## Technical Tips - INSERT HEAD Module

### MaxiMailer – Service Engineers’ Technical Tips Documentation – Jan 2007

The following documentation describes all MaxiMailer field issues and corrective actions. Please refer to these documents before any service or maintenance is conducted. Items **highlighted thus** are Jan 2007 additions.

## A-1. Motor Drive Belts and Pulley jumping and making noise

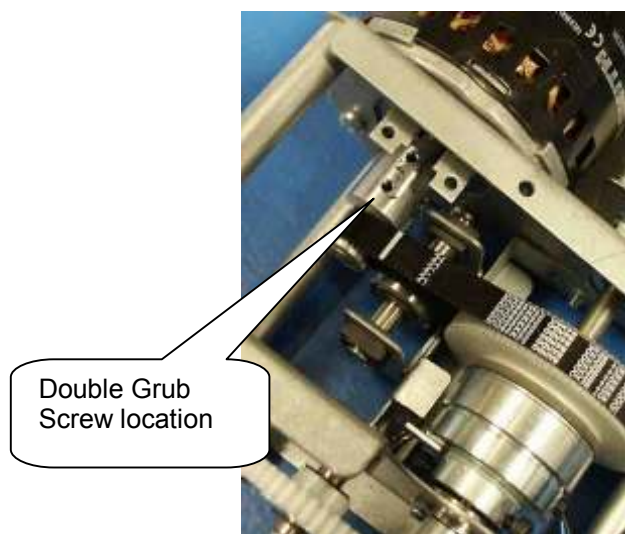
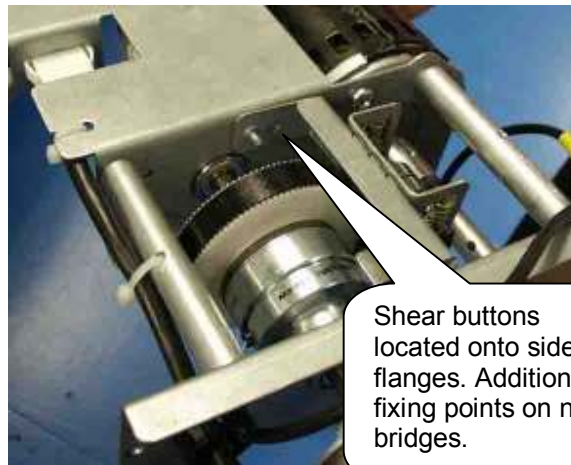
On machines pre June 05 the **Main Motor STS Belt (F5112A)** jumped on the pulley & idler assemblies causing a bumping noise from this area during running.

If this problem occurs on machines pre June 05, then the immediate field fix is to ensure the **idler bridge (B7420A)** shear buttons are located as illustrated below. Also, a very light smear of grease can be applied on the toothed side of the belt that will help until the belt settles in.

For a permanent fix, it is recommended a new **Primary Drive assembly A7068A (220V) or A7069A (110)** be fitted with all modifications.

Also, on machines (pre June 05) there have been instances where the **motor pulley F1372A (220v) and F1373A (110v)** became loose resulting in loss of drive and motor stalls. The corrective actions for this problem is to retrofit a double grub screw pulley **F1372A (220v), issue 2 or F1373A (110v) issue 2**, onto the modified Primary Drive assemblies.

## A-3. Misaligned Kicker Pawls – See A-3A for 2007 updates

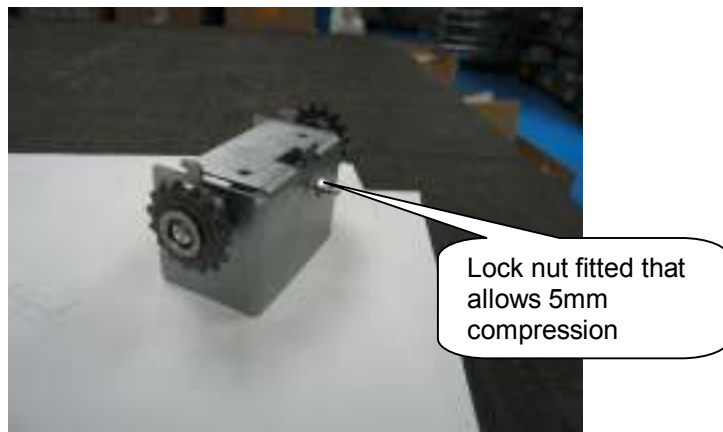
**Insert Kicker Pawls (B1818A)** are misaligned and cause a jam in the insertion area. The contributory factors and corrective actions are:-

1) Pawl link can lift above the centre panel (**B7468A**) page 4A-2 item 26 on one side only, causing the pawl chain to jam and jump. This has now been fixed by reforming the centre panel. If you find this problem order a new centre panel.

2) Wetter beam bounce – now eliminated by firmware upgrade (V4.0.0.12 or V3.4.0.12 **onwards**) that keeps the Solenoid Up ON for longer.

3) **Certain types of crashes cause the pawls to jump – in firmware version (V4.0.0.12 Dongle or V3.4.0.12 Pre-dongle onwards) the Insert pawls will now only move from the pause position when the wetter is home and the trailing edge of the envelope is seen at the wetter output sensor.**

**A-3A. Misaligned Kicker Pawls Jan 2007 updates** - There have been a number of mechanical changes that have been implemented in this area to improve the general reliability of the pawl track, these include:-

**a) Sprocket Shaft C9264A** – removal of grooves to improve fatigue strength.

**b) Sprocket Idler Shaft and Spigot C9418A and P2052A** – increased bore clearance for sprocket to prevent mechanism binding onto shaft.

### **Clutch Pin (G0079A)**

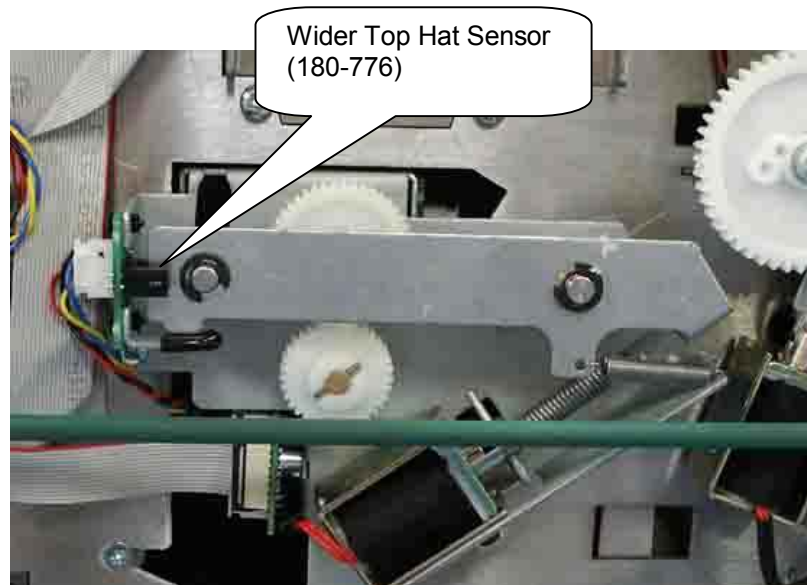
This pin can work loose if fitted incorrectly and introduce skew in the solenoid plunger causing the plunger to bind.

By pushing the pin home fully and fitting a small cable tie across the two pin legs it stops the pin from moving outwards.

## A-12 Insertion Crashes due to narrow inserts – Field Option

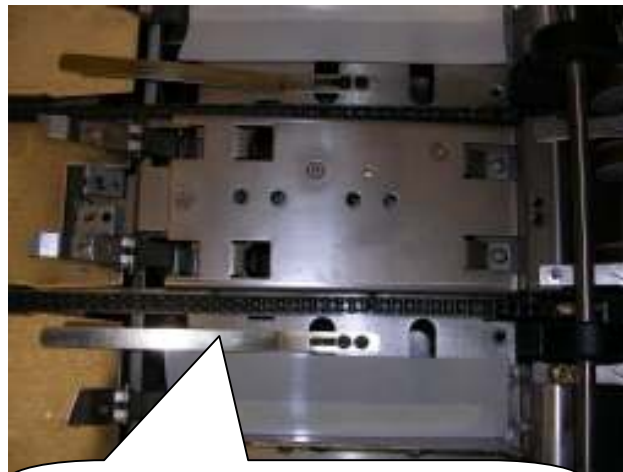
Tape to support pack in collate pocket - the tapes need to be 45mm long x 20mm wide and bent upwards 30mm from one edge. Double -side tape the remainder and fix inboard of the collate pocket side guides, making sure that they do not interfere with the fingers and collate pocket side guides.

Alternative field fix: spring steel can be secured to bed of collate pocket.

## A3287A Kit (wide collate pocket and fingers)

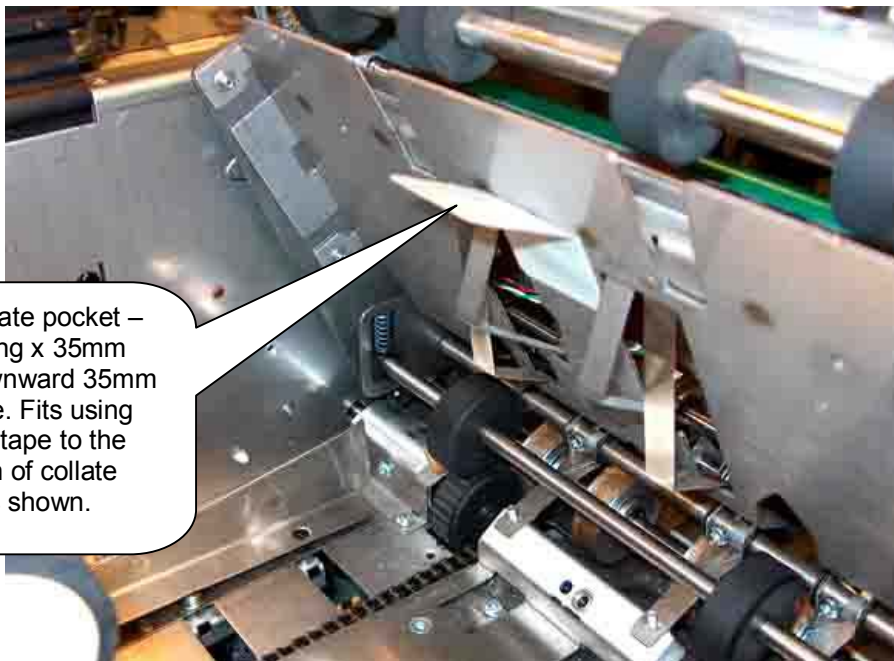
This new finger profile has been introduced to improve the envelope insertion caused by skewed envelopes from pick-up. These fingers (B9324A and B9325A) are shorter with a slight downturn at the tip. This also, enables inserts unto 40mm narrower than the prime document to be inserted without the need to sandwich in between other inserts.

Fig. 13a

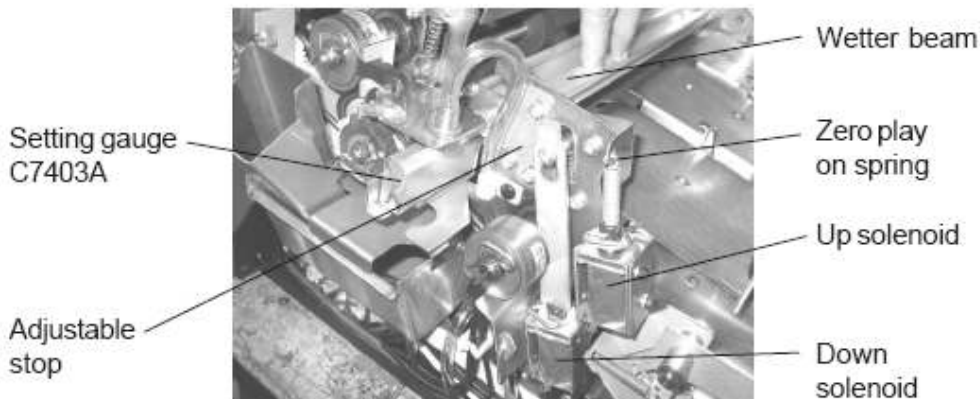
Setting procedure (refer to Fig. 13a above)

1. Remove/lower both side covers ([section 3.1.2](#))
2. Slacken the screws on the adjustable stop each side. Remove the wetter tank and replace it with the setting gauge C7403A.
3. Hold down the wetter beam to that it contacts the guage, then slide the adjustable stops so that they contact the spigots on the beam. Tighten the screws on the stops.
4. Slacken the adjustment screws on the down solenoid each side. Hold down the wetter beam and slide the solenoids so that the plunger is bottomed when the arm is pulling downwards to take out any play in the pivots. Tighten the screws.
5. With the wetter beam in its raised position, slacken the screws on the up solenoid and slide it so that with the plunger bottomed, any free play is taken out of the spring, without the spring being tensioned. Tighten the screws.
6. Replace the side covers. The wetter beam is now correctly set.

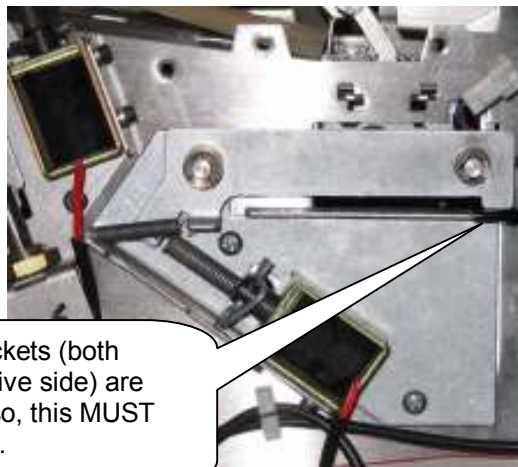
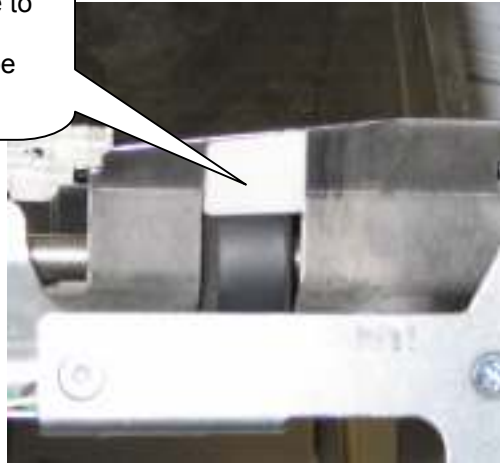
**NOTE: fit tape onto envelope feed bridge B7496A to prevent catching on cut-outs as shown below. In addition, check and ensure that the finger brackets (both operator and drive side) are not bent-up as shown below. If so, this MUST be straightened.**

Mylar fitted to prevent fingers catching on cut-outs (2 posn G6210A and G6211A) – see below.

### k) Stiff chain and pawls not fitted correctly

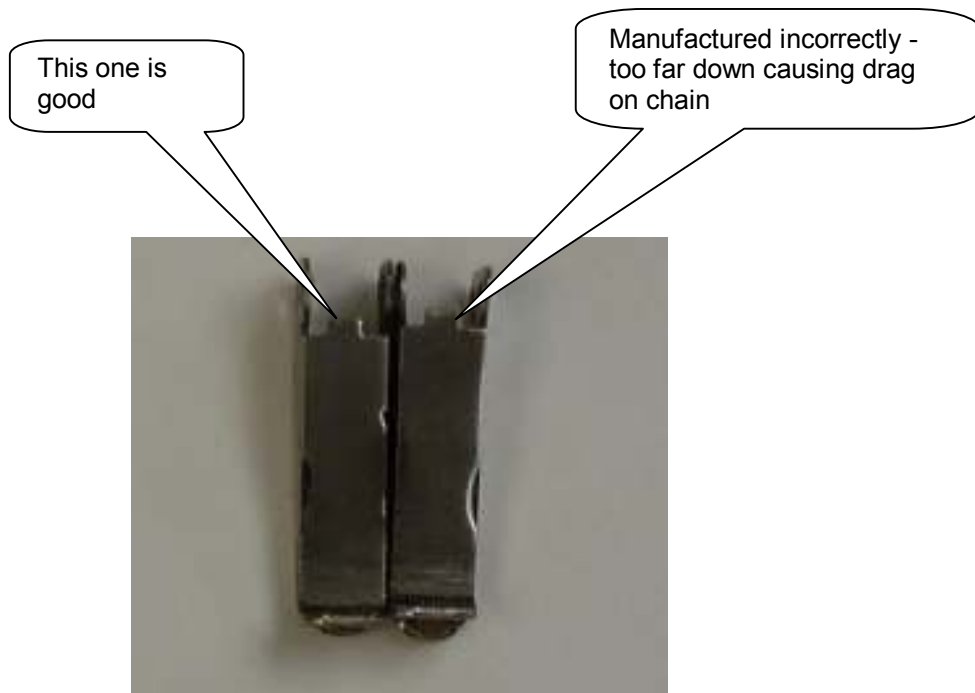
If experiencing sporadic insert crashes - check insert pawls are aligned with each other and that there is no resistance when manually moved (to check this turn by hand one complete cycle). Check that the pawls are manufactured incorrectly - if not they could drag on the insert chain, see below.

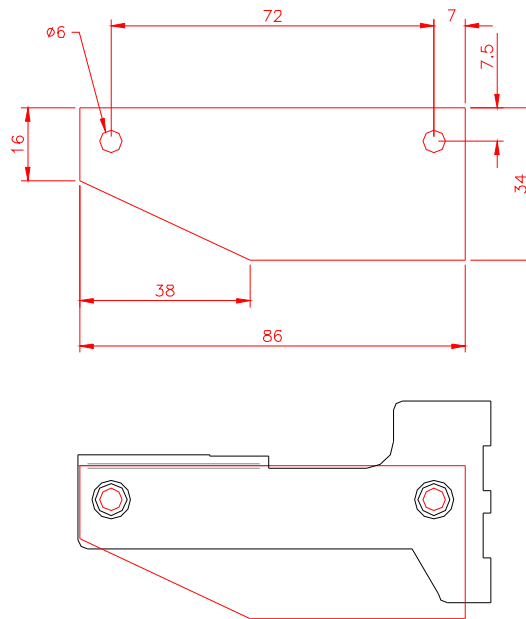
l) A Mylar strip (part number G6195A) can be fitted for particular envelopes with a short flap shoulder - this may be required to prevent the insert catching on the edge of flap during insertion.

Material: 0.25mm(0.010") Polyester Shim Stock (Mylar). Clamped between Aluminium bar and 'T' pieces (clamped not stuck down).

## **A-19. Belts jumping on Head Upper clam assembly (A7041A).**

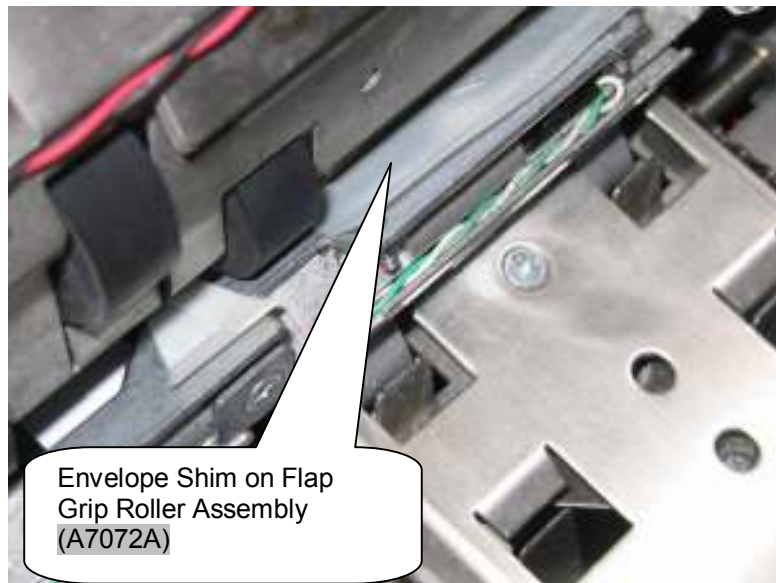
Clean ALL pulleys and idlers to remove the toner that has deposited onto the teeth form - do not use grease. If problem persists replace ALL Aluminium 25T pulleys with **Plastic 25T (F1375A) pulleys.**

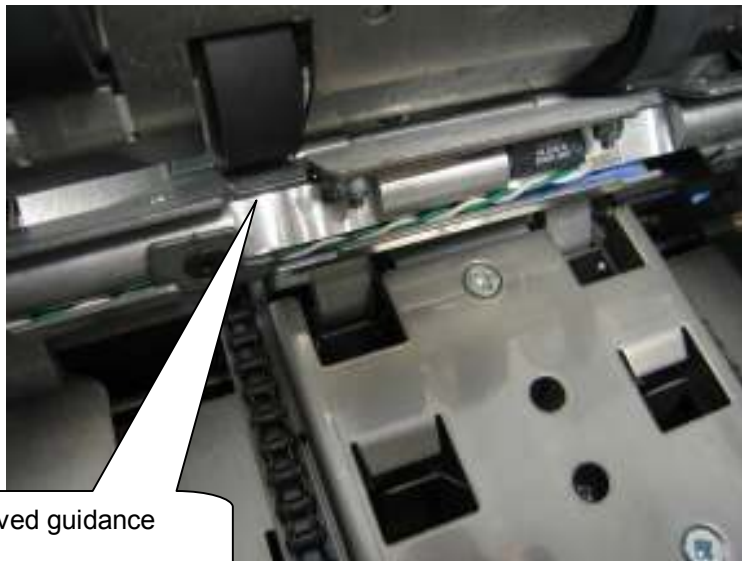
**Problem resolved on machine (effective from July 06) – if experiencing problems in this area then fit complete new assembly A7072A.**

**Various areas around this assembly (A7072A) have been modified to give greater clearance on the envelope as it is driven through the envelope feed path into the insertion area.**

Previously envelopes could distort and catch on the assembly at various points. The bar that holds the small diameter 'grey' flap grip rollers has been modified to prevent the roller from 'locking' and forming flats after time.

- Edge deflector B7714A improved to give better guidance into flap grip area.
- Envelope Defector R2175A improved to give better guidance into flap grip roller.
- Envelope guide bar C9436A. Chamfers added to cutaways to remove potential catch points.
- Guide tapes added to envelope feed to prevent fingers catching on edge of wheel cutouts.
- Flap grip roller bar C4363A bearing shoulder changed to remove potential bearings snag.

Pin (E5078A) in Envelope or Insert feeder Pick-up shaft is not working loose – Loctite pin to prevent this from occurring.

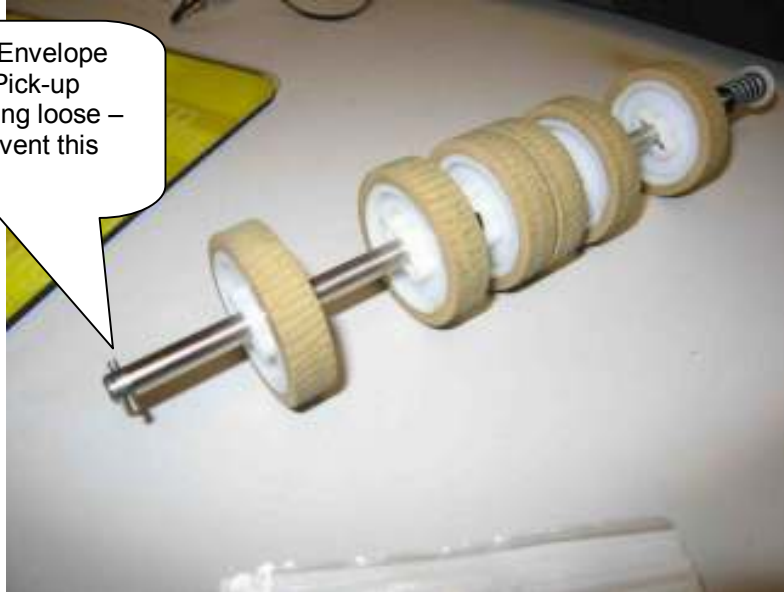
Check and ensure pin (E5078A) in the **Envelope or Insert feeder Pick-up shaft** is not working loose - see below. If so, it will damage the ribbon cable and short-circuit the relevant sensors. The corrective action in the field is to apply a dab of Green Loctite around the pin and any excess to be cleaned off to ensure the pin does not become loose.

### **A-22. Sealer Closer Assembly (A7046A) - black tape fitted to prevent reflecting of metalwork - Field Option**

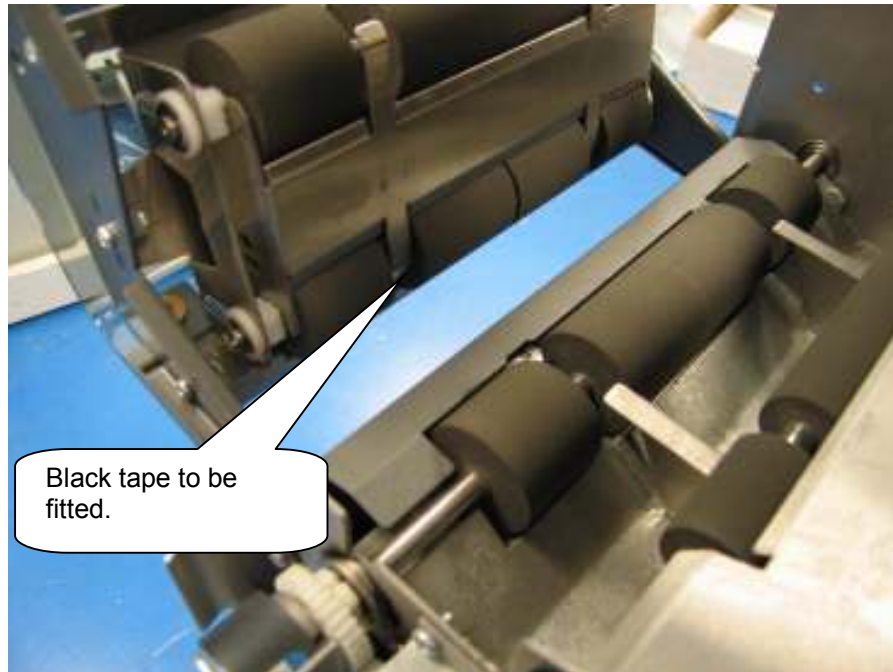
There has been one instance of envelopes exiting the machine without closing the flap resulting in error 47 (jam at output sensor). Initially check by blocking/ clearing the closer output sensor (analogue reflective sensor). If the sensor stays blocked - at the first instance try moving the machine away from light. If this is not appropriate BLACK insulation tape can be fitted onto the closer overguide B7731A as shown below.

## A-27. Envelope Deskew Sensor Errors

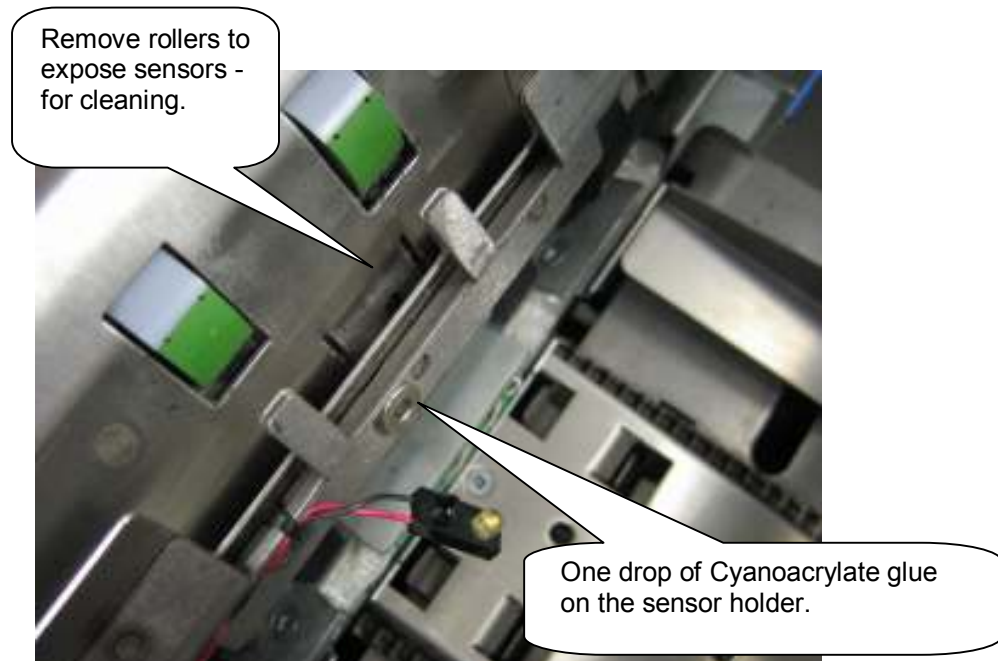
In some instances we have found there is too much movement within the sensor holder - if this is the case it is advised to place one drop of Cyanoacrylate glue on the sensor holder as shown below. Once aligned re-calibrate sensor and check by running envelopes for above error. A new sensor bridge (B1797A, issue 4) has now been modified to prevent the sensor from moving within the holder and can be fitted if required (optional).

### A-29. Power Supply 26V low (error 1054 on version 3 on upwards)

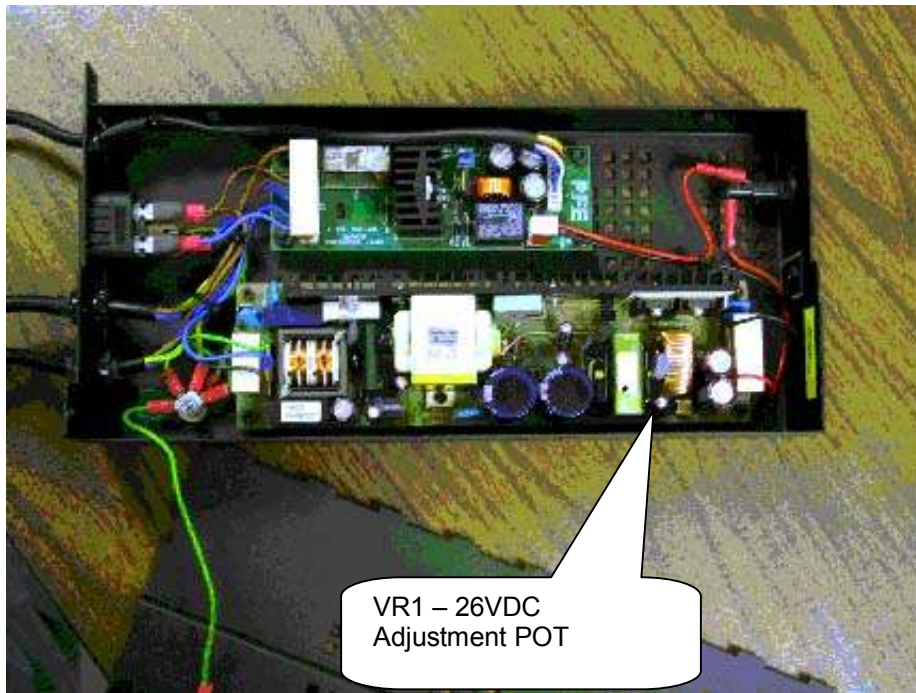
When Upgrading to Version 3 Firmware – there is a potential for the above error to occur. Version 3 of the firmware performs an analysis of all system components at power up or reset. After upgrading to Version 3 firmware you may start getting error 1054, 26Volt Supply is low. There is an adjustment that can be made on the module Power Supply board to adjust 26VDC. This potentiometer (VR1 – see picture below) is very sensitive. Very small movements can make 5 or more volt adjustments. Adjustments can be checked via the GUI display, or using a meter. To do the adjustment with a meter, dis-connect the 24v cable from power supply to the module board. Measure voltage on the power supply across YLW (pin1) and BLK (pin5 or 6) - this should be about 26v.

### A-36. Flap catches on the Envelope Opener (Field Option) – see A36A for 2007 updates

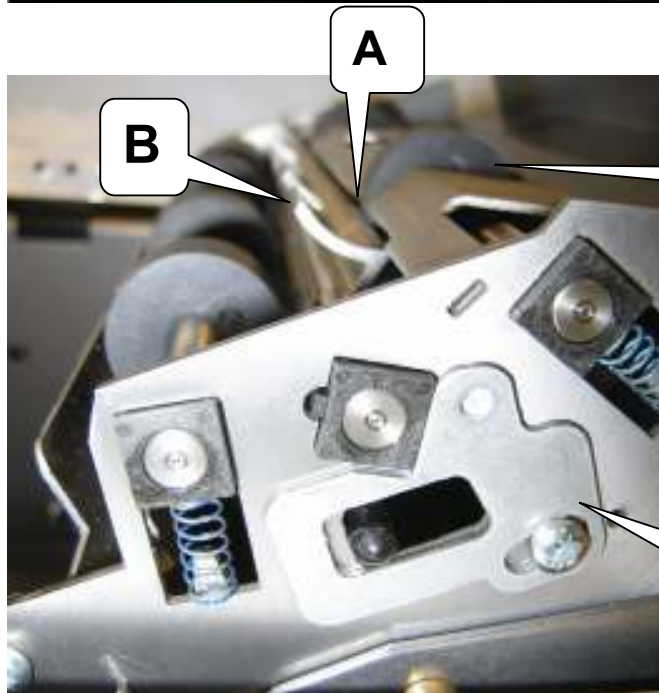
There have been instances of the flap missing the opener due to the curl on the flap (caused by excessive glue). At the first instance check set-up of the opener as shown below:-

A - when the deskew rollers are compressed (when the pocket is closed) ensure opener edge is NOT touching deskew rollers.

**Envelope opening issues** with particular curly flaps – a modified extrusion is now available and can be fitted to overcome this problem (assembly number is A7380A which is fitted with envelope opener curled flap C7419A).

#### **Parts required:**

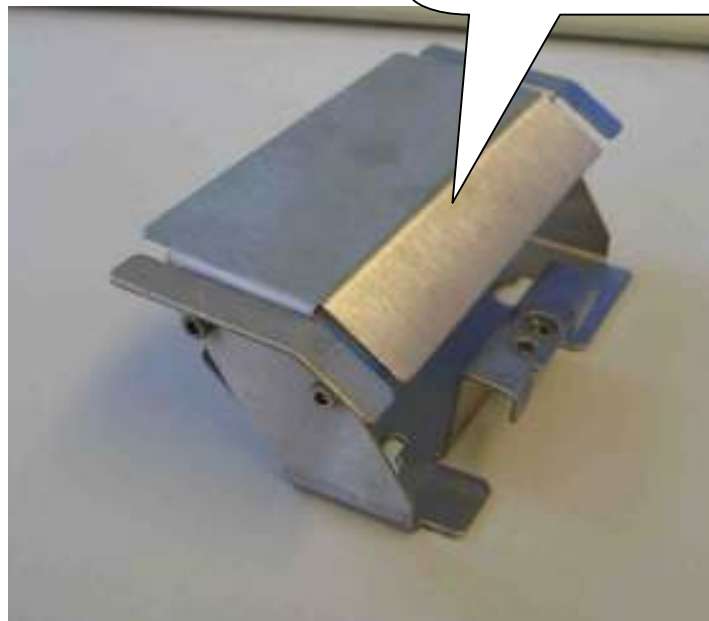
If there is a requirement to run the machine in NO-Seal Mode and closing flaps - there is a potential with certain envelope flaps to catch on the sealer ski. If this occurs a no seal bracket (B9120A) can be clicked into place to provide support of the envelope flap as and when required. Note that this part can only be fitted with the latest version of the sealer ski (B7464A issue 2 or later).

- 1x B9120A No seal bracket
- 1x B7464A Sealer Ski (latest version)
- 4x P2278A Pusher Pivot
- 4x E2771A M3x8 Cap Hd St. Steel
- 0.07m x E0422A Vinyl Tape
